<b>Title - Sujet</b> CCG WP 2.0 Construction	
<b>Solicitation No. - N° de l'invitation</b> EB144-182527/A	<b>Amendment No. - N° modif.</b> 001
<b>Client Reference No. - N° de référence du client</b> EB144-18-2527	<b>Date</b> 2018-02-14
<b>GETS Reference No. - N° de référence de SEAG</b> PW-\$PWA-405-5718	
<b>File No. - N° de dossier</b> PWA-7-78131 (405)	<b>CCC No./N° CCC - FMS No./N° VME</b>
<b>Solicitation Closes - L'invitation prend fin at - à 02:00 PM on - le 2018-02-27</b>	<b>Time Zone</b> <b>Fuseau horaire</b> Atlantic Standard Time AST
<b>F.O.B. - F.A.B.</b> <b>Plant-Usine:</b> <input type="checkbox"/> <b>Destination:</b> <input checked="" type="checkbox"/> <b>Other-Autre:</b> <input type="checkbox"/>	
<b>Address Enquiries to: - Adresser toutes questions à:</b> Kendell (PWA), Byron	<b>Buyer Id - Id de l'acheteur</b> pwa405
<b>Telephone No. - N° de téléphone</b> (902) 402-9436 ( )	<b>FAX No. - N° de FAX</b> (902) 496-5016

**La modification 001 vise à indiquer ce qui suit:**

Niveau 300 révisée aménagement conformément au document ci-joint des croquis.

CCG WP2.0 FIT-UP  
MARITIME HEADQUARTERS  
BEDFORD INSTITUTE OF OCEANOGRAPHY  
DARTMOUTH, N.S.

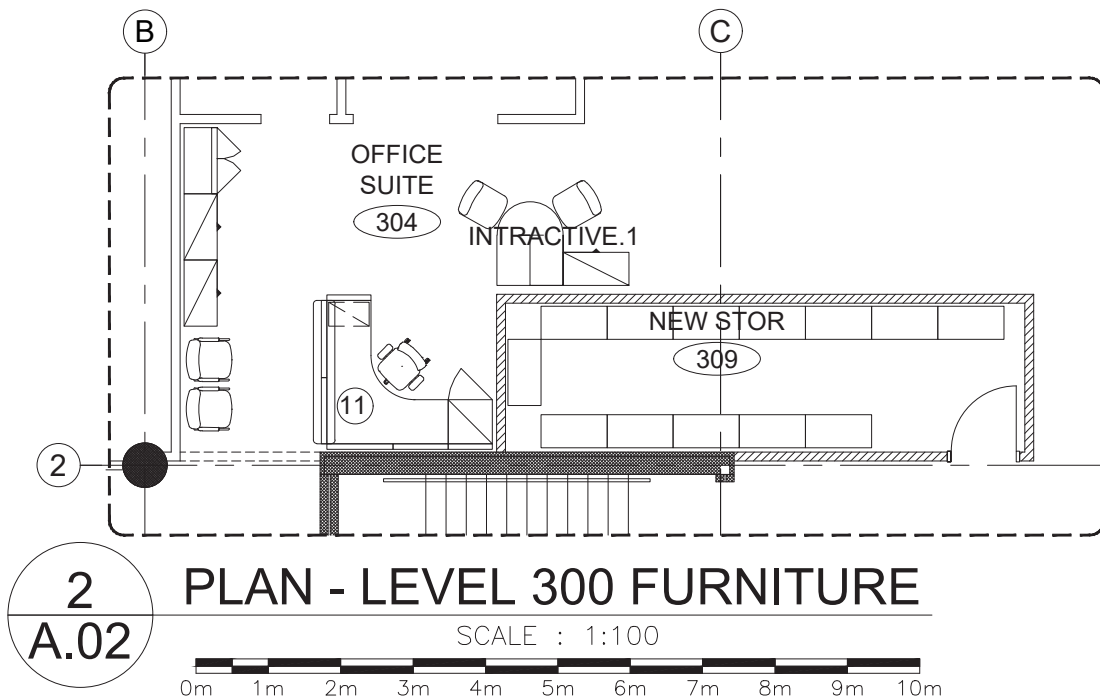
A) WORKSTATIONS # 11, 12 AND 13 ON LEVEL 300 AT GRID LINE C2 ARE TO BE DISMANTLED AND STORED IN A SECURE PLACE. WORKSTATIONS ARE TO BE REASSEMBLED. FINAL FLOOR/POSITION TO BE DETERMINED.

B) WORKSTATION #11 IS TO BE DISMANTLED AND STORED IN A SECURE PLACE DURING CONSTRUCTION OF THE NEW 308 STORAGE ROOM. ONCE THE LEASEHOLDS ARE COMPLETE THE WORKSTATION IS TO BE REASSEMBLED IN THE SAME LOCATION BY THE FURNITURE INSTALLER.

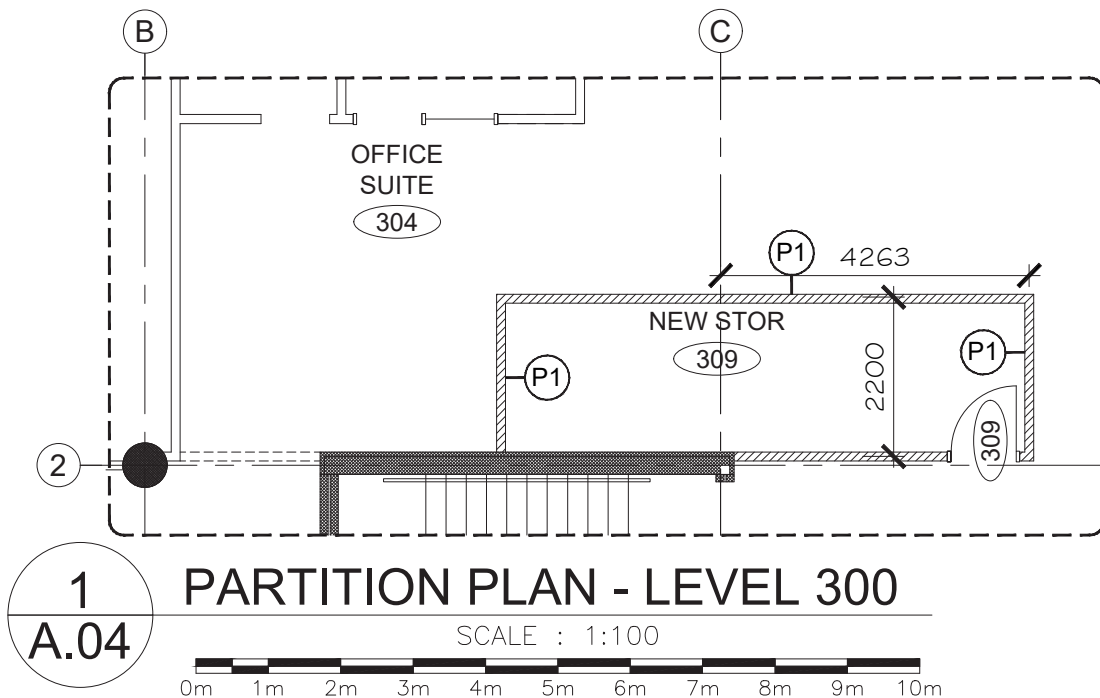
RELOCATE NEW STORAGE ROOM 2463mm  
EASTWARD AS INDICATED.

EAST WALL TO ALIGNED WITH EAST CORRIDOR  
WALLS DEFINING SERVERY AND NEW MEETING  
ROOMS.

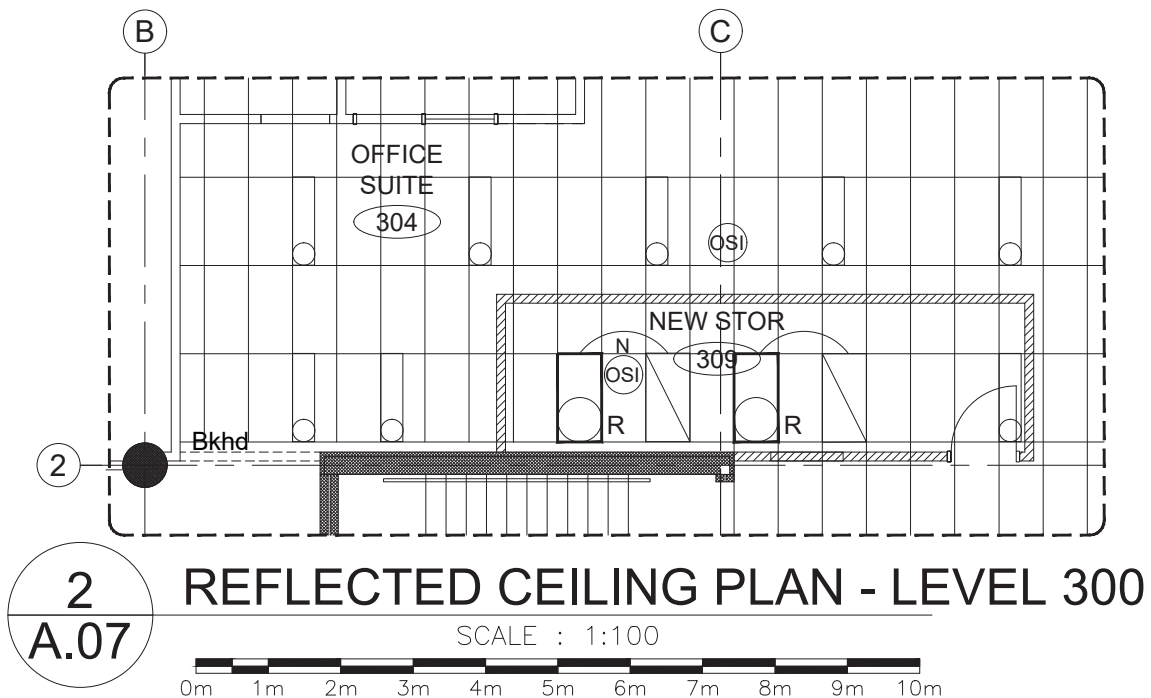
RELOCATE / REUSE LUMINAIRES AFFECTED BY THE  
RELOCATION OF THE NEW STORAGE ROOM  
EASTWARD.

REFER TO ELECTRICAL DRAWINGS FOR SPECIFICS.

## PARTIAL LEVEL 300 FLOOR PLAN - LIGHTING

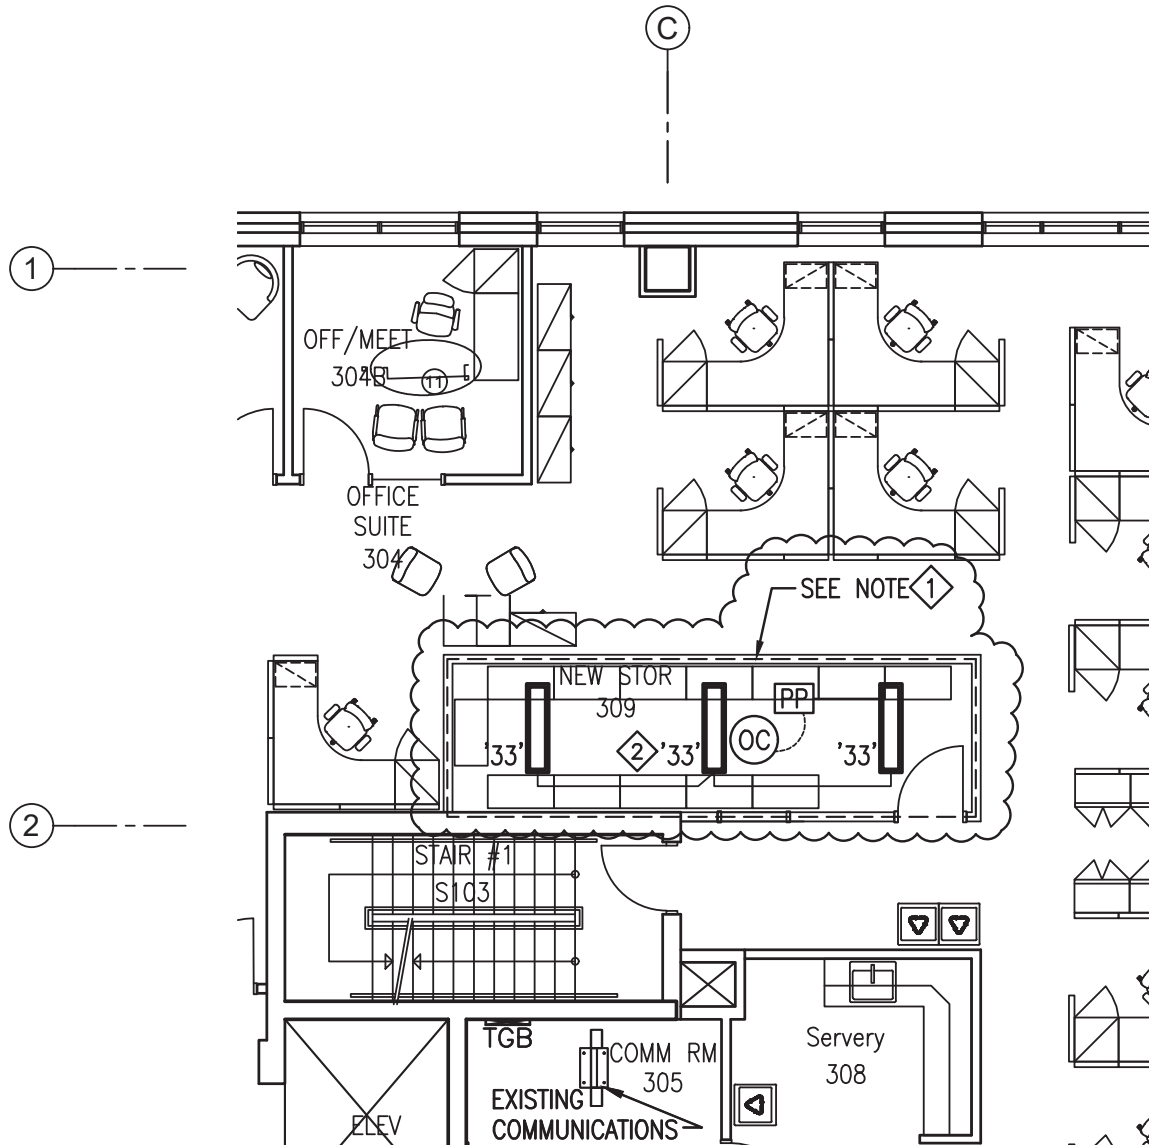
DISCONNECT AND REMOVE EXISTING LIGHTING WITHIN DASHED IN AREA.  
MAINTAIN CIRCUIT CONTINUITY TO ALL REMAINING DEVICES.
